PROPOSED LAND LEASE COMMUNITY – COLLEGE DRIVE, FLAGSTONE EDQ FURTHER ISSUES LETTER RESPONSE – EDQ REF. DEV2024/I532

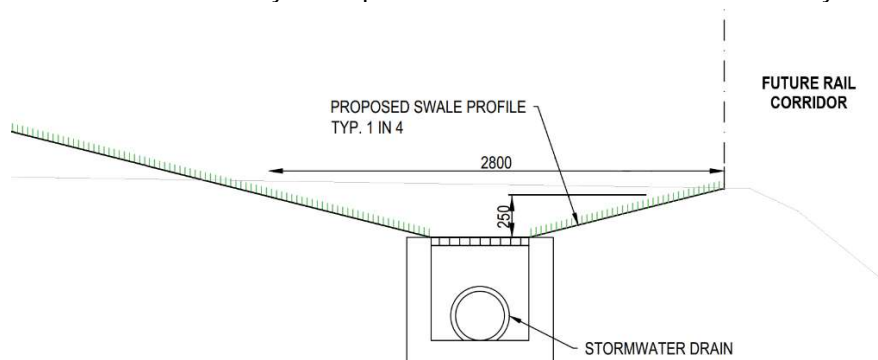
9. Confirm the maximum depth of flows within the northern swale and any impacts on the proposed boundary fence and adjoining northern residences.

Given the very minor catchments involved, peak Q100 runoff in the northern swale will be contained within the pipe system. However, conservatively assuming 100% pipe blockage the maximum flow depth in the swale will be approximately 95mm at the western end of the swale.
